APPLICATION NO.	FILING DATE	FIRST NAMED INVENTOR	ATTORNEY DOCKET NO.	CONFIRMATION NO.
10/807,590	03/24/2004	Mark Girard	706195-2001	3798
7590 Bingham McCutchen LLP 2020 K Street, NW Washington, DC 20006				
EXAMINER				
DESANTO, MATTHEW F				
ART UNIT		PAPER NUMBER		
3763				
MAIL DATE		DELIVERY MODE		
12/23/2010		PAPER

Office Action Summary

DETAILED ACTION

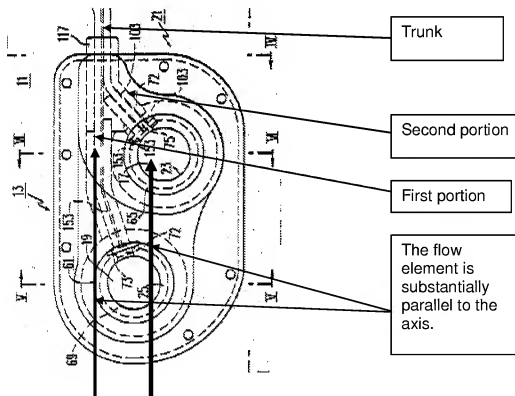
With regards to claim 3, 4, 16, 27 Cupp discloses the first and second walls are positioned along an axis of the housing and wherein the first and second arms extend from the trunk at angle relative to the an axis and the trunk extends in a substantially parallel direction to the axis [can be seen in figure 2 and 7 as well as shown in the drawing in the response to arguments section (see below)].

With regards to claim 5, 15, 25, 26 Cupp discloses the arms extend from the trunk at an acute angle as shown in figure 2 and 7. Even though the reference is silent to the angle it would have been obvious to modify the angle to be between 30 and 60 degrees.

7. The examiner maintains his rejection of Cupp et al. in view of Ensminger because of the decision by the BPAI.
8. With regards to both rejections the applicant fails to show criticality for the opening as well as the specific shape of the arms and lumens, thus the examiner maintains his rejections, since one skilled in the art would find the modification an obvious design choice.
9. Cupp et al. teaches the "f shaped flow connector" with the first portion on the first arm and the second portion in the second arm. See the image below and figure 4 in Ensminger shows a gap between the first and second portion and the housing.
